SERVICE No. 544 BULLETIN

Piper Aircraft Corporation

Airspeed Placard Installation

PA-31-325 Navajo.....31-7400990, 31-7512006 to 31-7612110 Inclusive

New Airspeed Placard 80486-02
(Locate as shown)

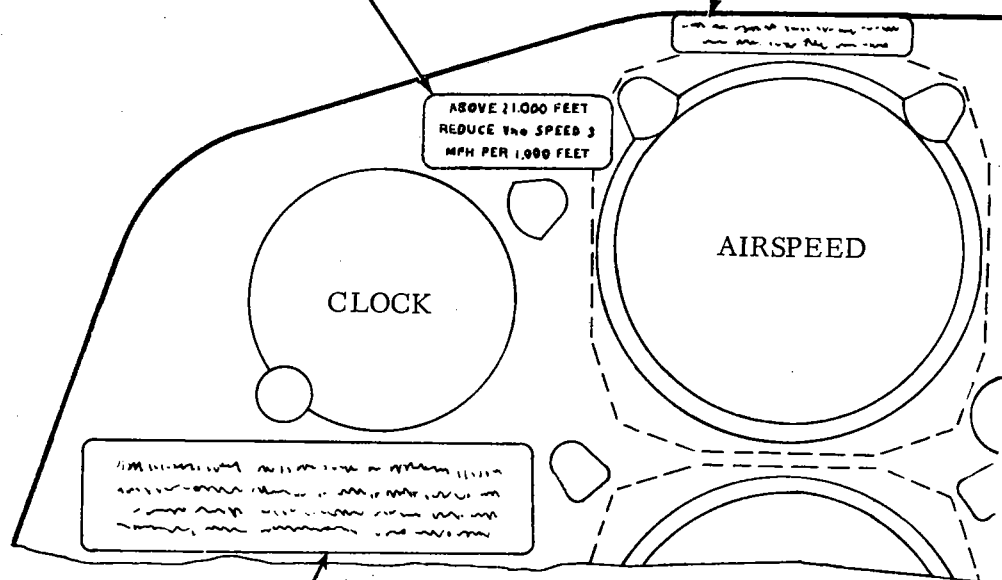
Purpose: To provide material and instructions to add an airspeed placard adjacent to the Airspeed Indicator referring to V_{NO} (upper limit of green arc) operation above 21,000 feet. This placard is shown in its proper location on the illustration on reverse side.
